UNITED STATES PATENT AND TRADEMARK OFFICE

| APPLICATION NO. | FILING DATE | FIRST NAMED INVENTOR | ATTORNEY DOCKET NO. | CONFIRMATION NO. |
|-----------------|-------------|----------------------|---------------------|------------------|
| 09/476,521 | 01/03/2000 | Herbert Gropp | RUM212 | 7964 |

Office Action Summary

Fig. 1.

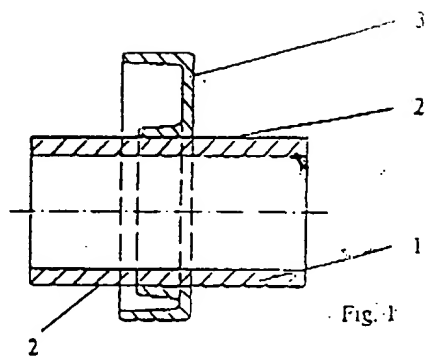
(a) the drawings should show the plane upon which a sectional view such as Fig. 1 is taken; and

The original drawings merely show: (a) the pipe 1 as described on page 6 of the specification; and (b) only two coatings (*i.e.*, first and second coatings) 2 and 5 as described in the original specification.

Claims 9 and 10 now call for the *third* compression joint, and the *third* crystalline phosphate coating. However, the original drawings (Figs. 1-3) show only two coatings 2 and 5 as described in the original specification. Claims 9 and 10 now claim three coatings as evidenced by the term “a *third* crystalline phosphate coating.” The third crystalline phosphate coating is unsupported by the record as filed.

Fig.3

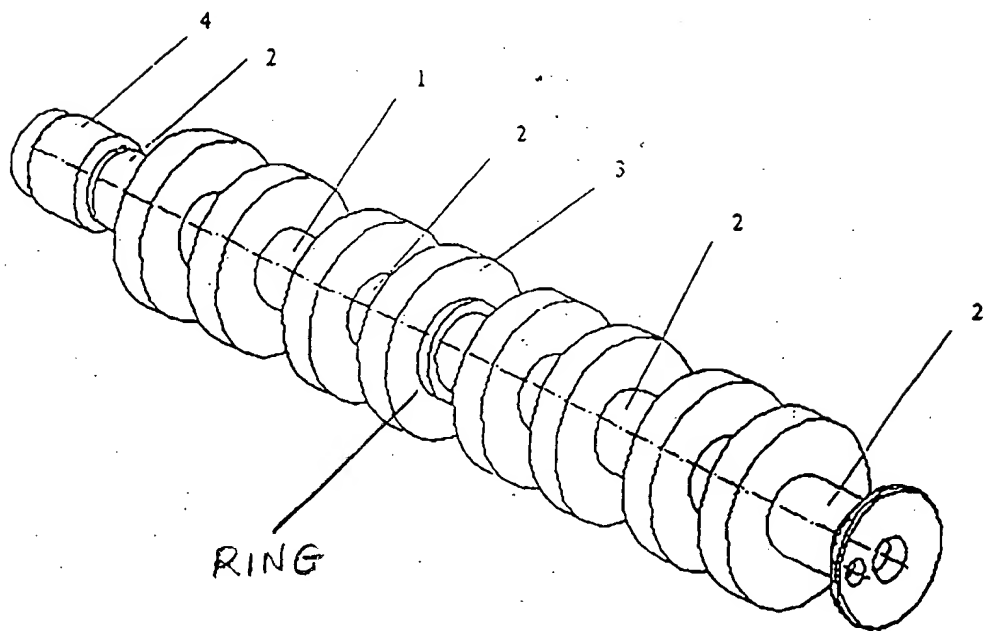
- (b) new Fig. 3 introduces new matter, such as, the deletion of a ring (unnumbered, see Exhibit attached). The original Fig. 3 shows the ring located adjacent to the cam 3, however, new

Fig. 3 now does not show such ring. See *Twin Disc v. United States*, 231 USPQ 417, 435 (US Cls. Ct. 1986)(new matter by deletion).
